PLANNING BOARD AGENDA
OCTOBER 12, 2023– 7:00 P.M.

RE: Diamond Point Development
4 Baldwin Place Road
Town of Carmel
TM#s: 86.10-1-2&3

In response to open comments received from Director of Code Enforcement, Michael Carnazza, dated September 11, 2023, we offer the below responses. Please note that the below only responds to comments not indicated as previously addressed:

In response to open comments received from Town Engineer Richard Franzetti, PE, dated September 6, 2023, we offer the following responses:

SIGN 2

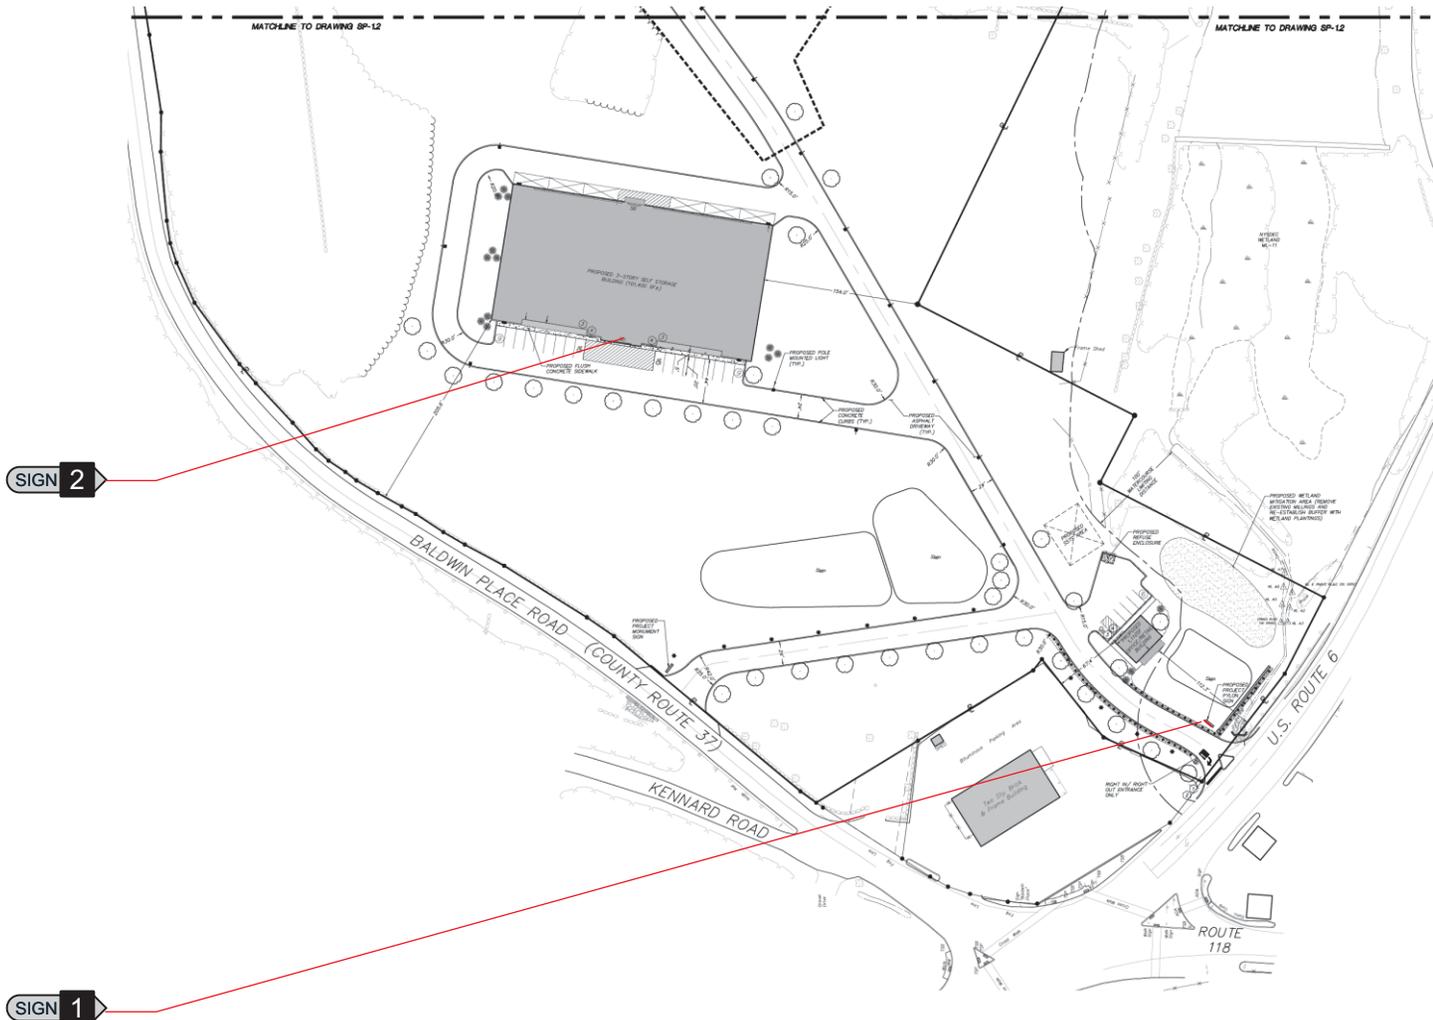
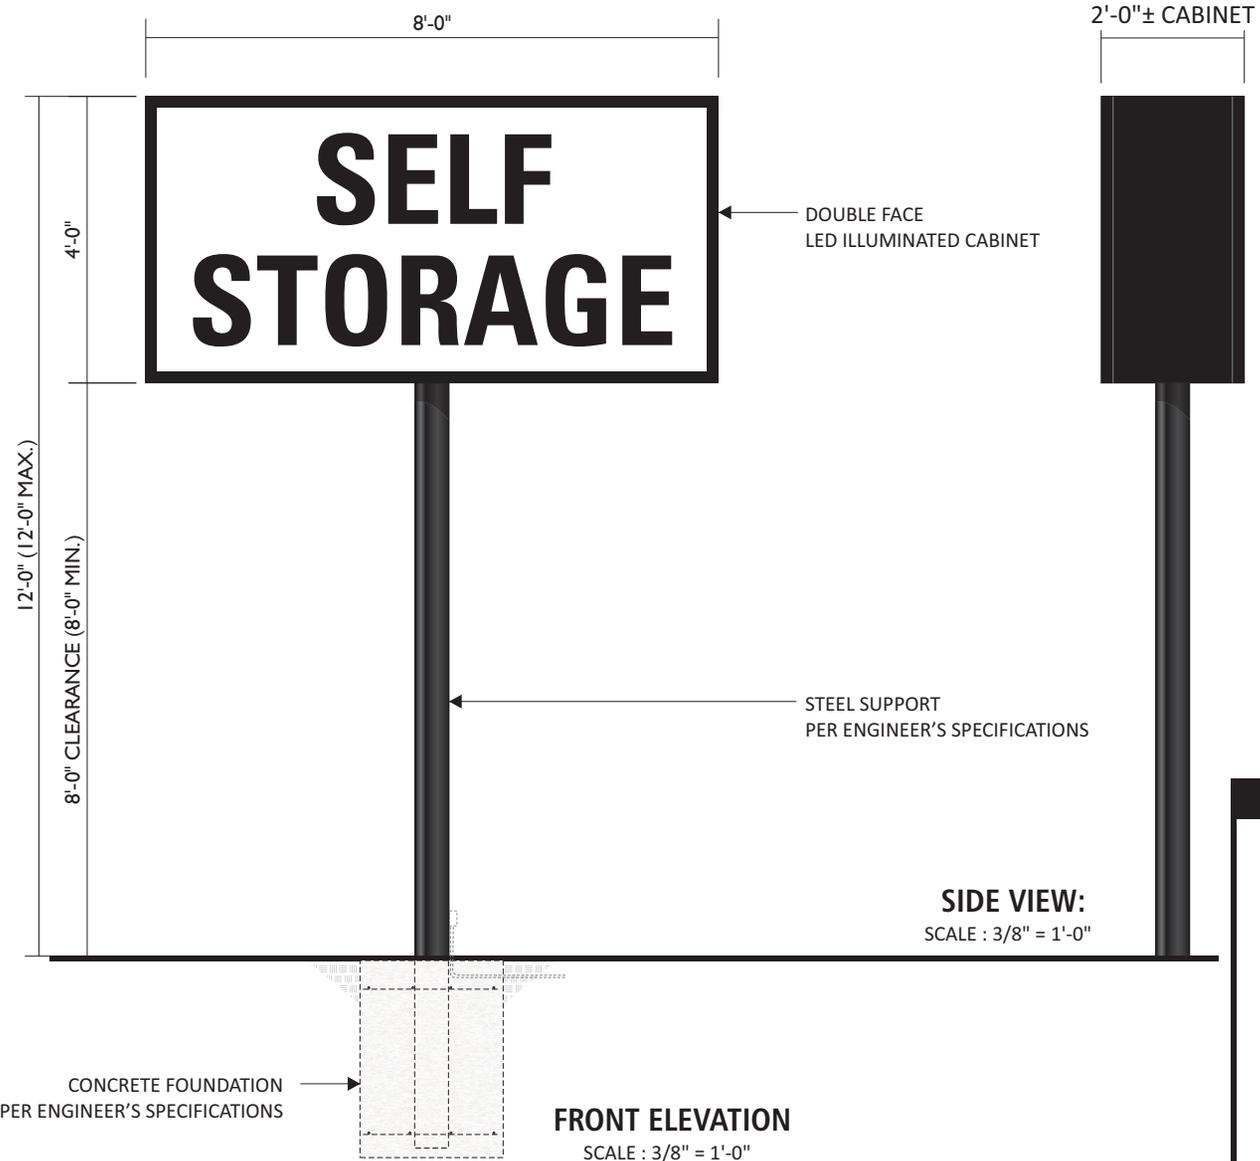
2. There will be one sign near the Route 6 entrance and one building mounted sign. See the enclosed Signage Design Drawings.
3. See the enclosed Conversion Parking Plan.
4. The building has been sited based on a number of factors. These include cut fill analysis, driveway slopes, and the need for stormwater practices downhill of the proposed development. This being the case, the current location of the main storage building cannot be moved closer to the road. It is also believed that by moving it closer to the road would give the building a bigger presence along the property frontage.

DRAWING NO: **SP-1.1**
SHEET: 4 OF 16

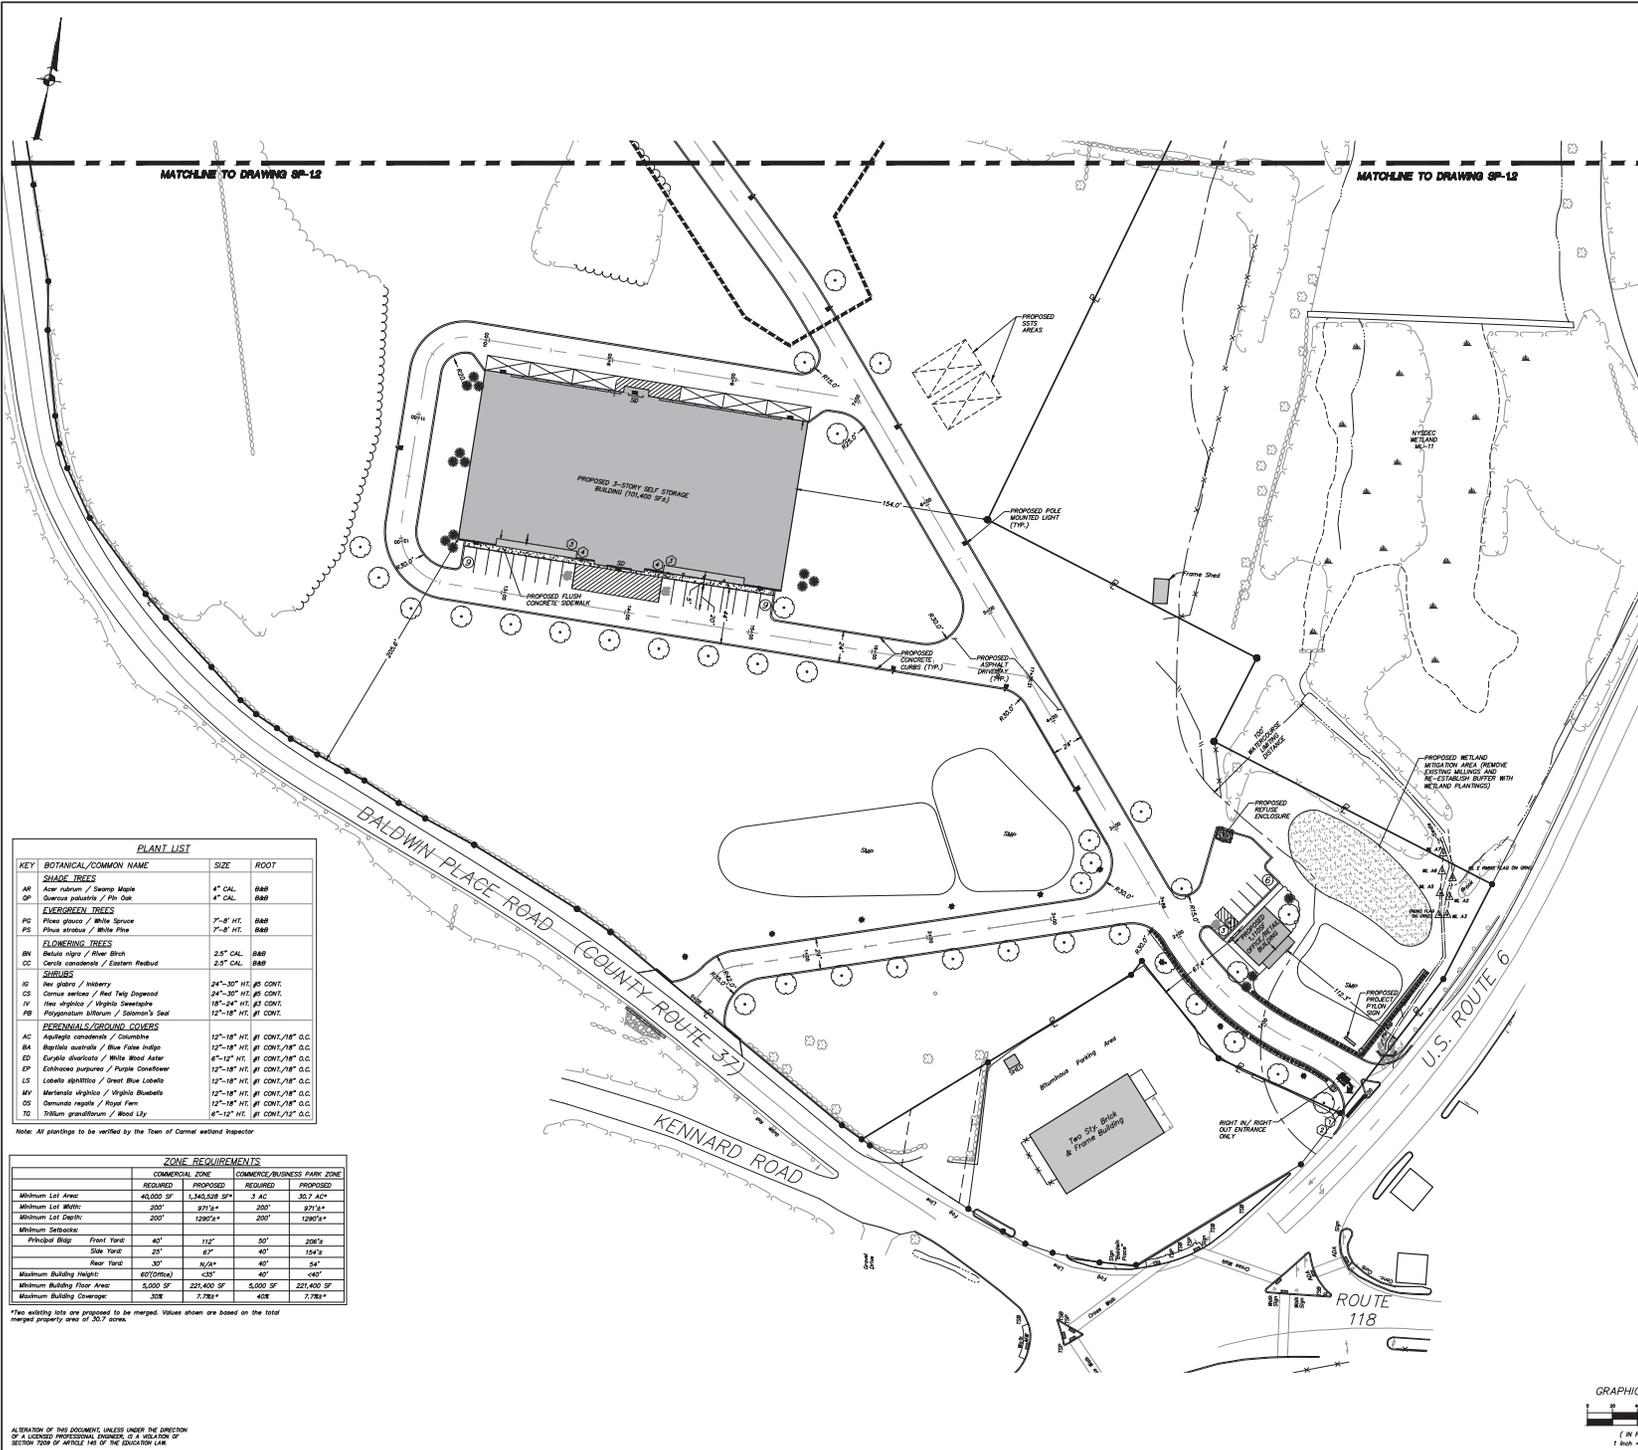
4. Landscape & Layout Plan
 - a. A note regarding the plants being verified by the Town of Carmel Wetland Inspector has been added to drawing SP-1.1.
 - b. Photometric lighting plans (drawings LP-1.1 & LP-1.2) has been added to the drawing set.

DRAWING NO: **SP-2.2**
SHEET: 7
16

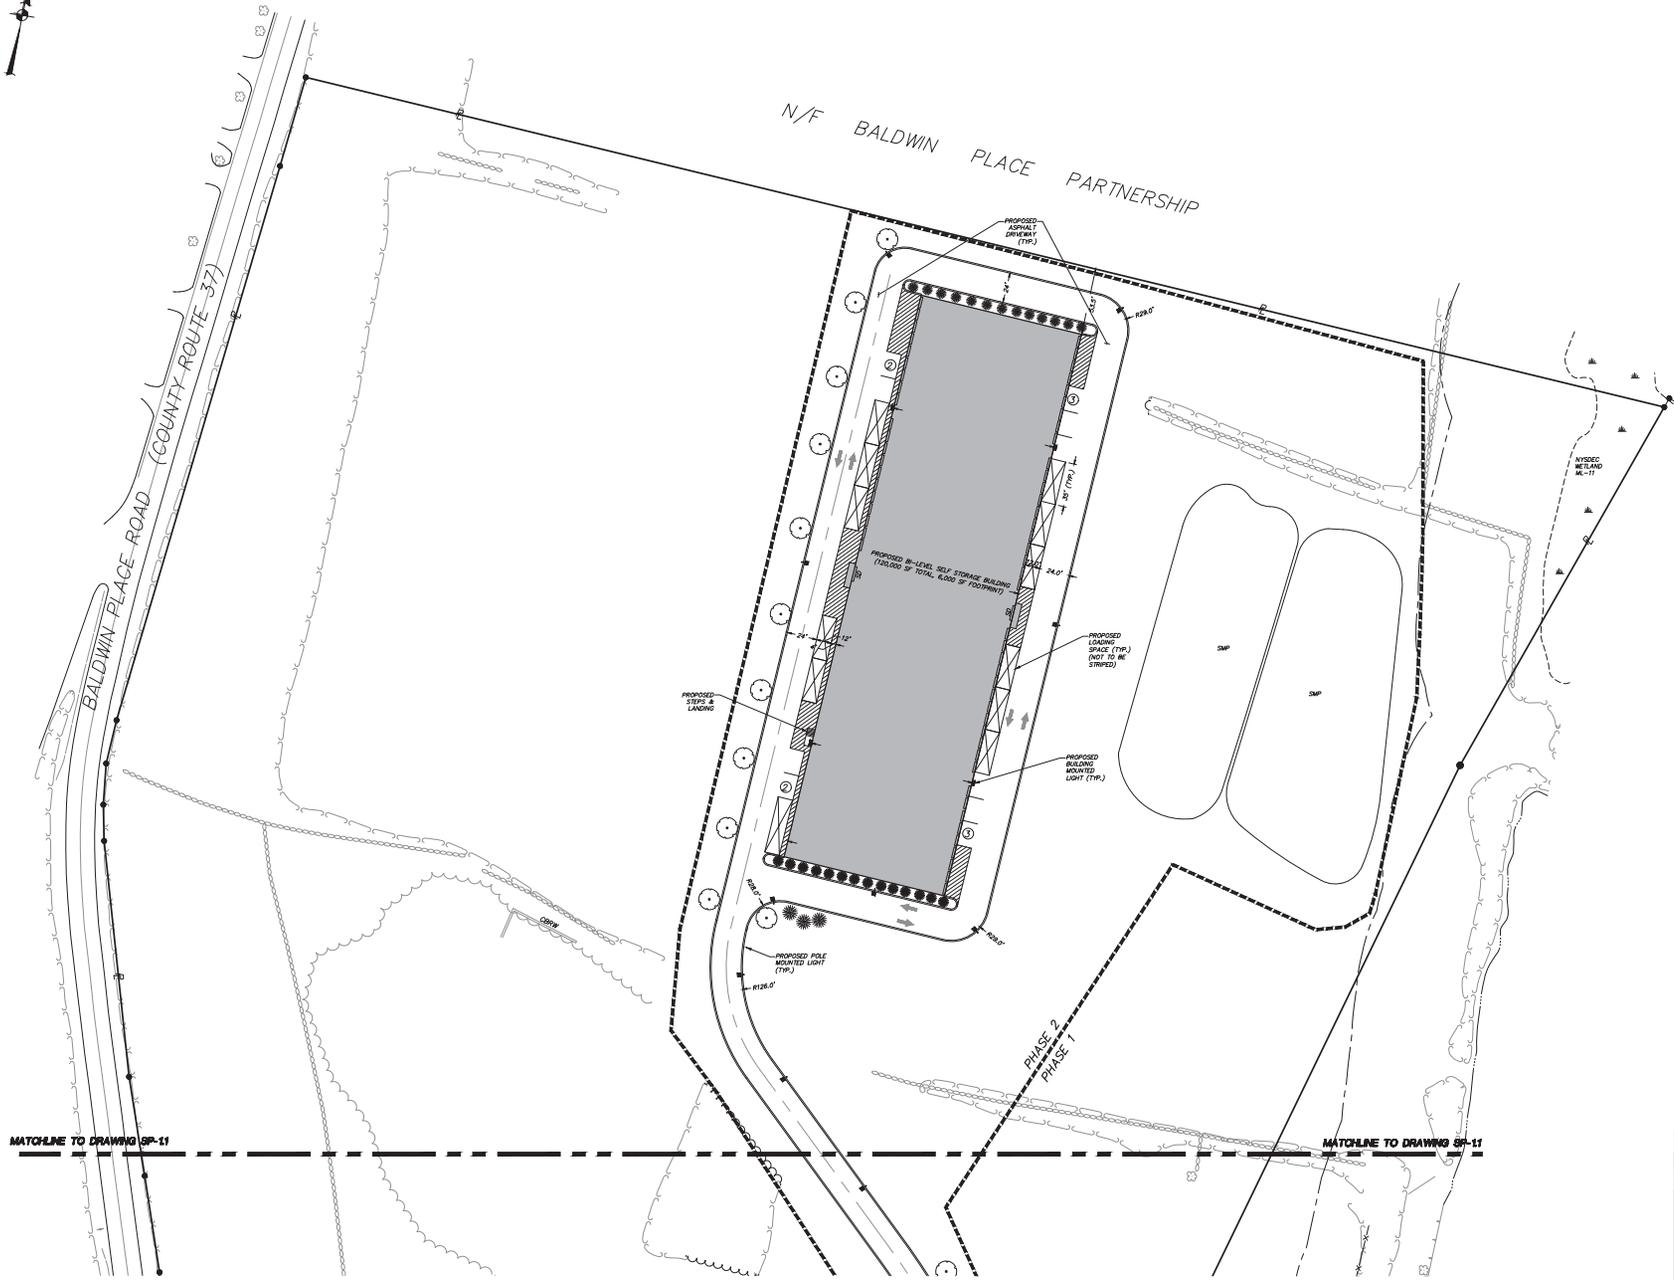
3. Details on the well and septic system have been added to the plans. The proposed fire protection tanks are shown on drawing SP2.2. Construction details for the system will be submitted by the applicant's MEP Engineer separately.
